# **Addendum No. 1**

## **Town of Winthrop SR 20 Chewuch Bridge Pedestrian Underpass Project**

**Addendum No. 1**  
**ISSUED: May 11, 2026**

### 2. Drawing DM-01, Sheet 4 of 24

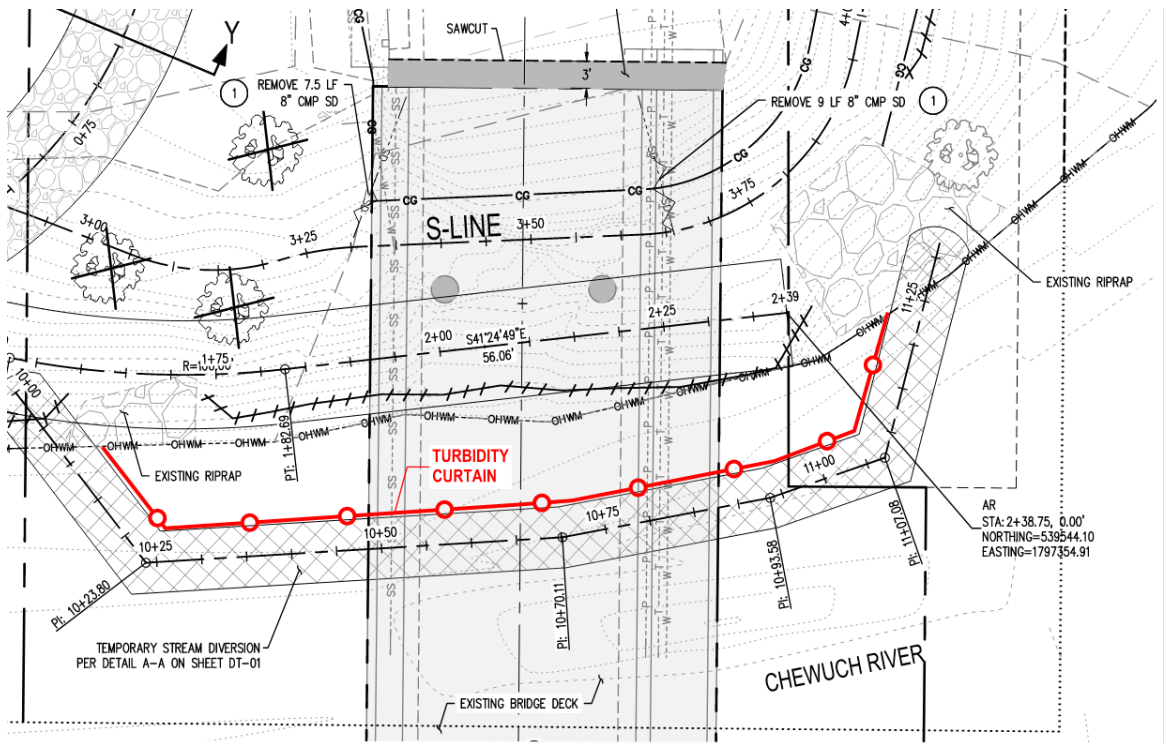
1. Add a Turbidity Curtain located along the inside edge of the temporary stream diversion as illustrated below
